**Conditions of development consent for the Sydney Metro Martin Place Station Precinct
SSD 9270 – North Site**

Condition B5, B6 and B7 discharge request #3 – Design excellence and design integrity review

Figure 1 Comparison of approved Level 28 BMU openings (outlined red) and proposed reduced BMU openings (outlined in black) – south elevation Level

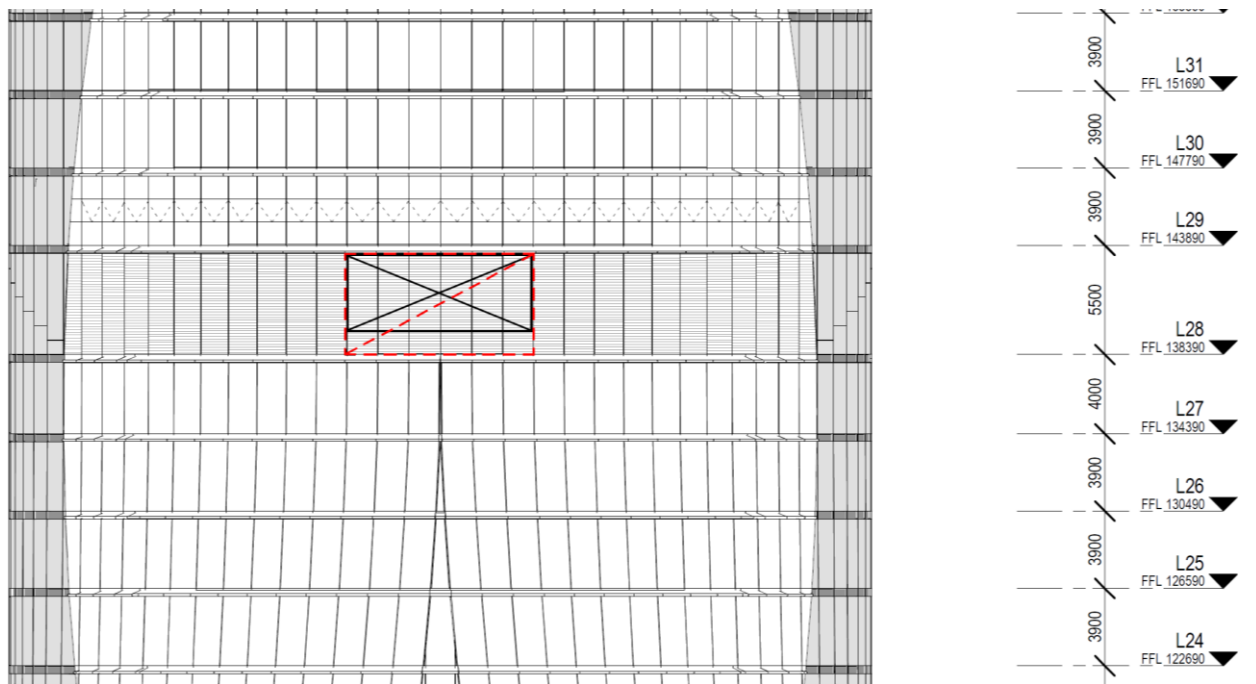
Accordingly, this letter is prepared in accordance with Condition B5 and sets out a proposed design change to the approved BMU openings for the North Site, located on Level 28 and the upper roof level of the southern facade. The proposed change seeks only to reduce the size of the BMU openings (maintaining the approved positions and design), and is the result of the design development / construction certificate drawing process. The minor design change is considered positive, reducing the extent of the required openings only.
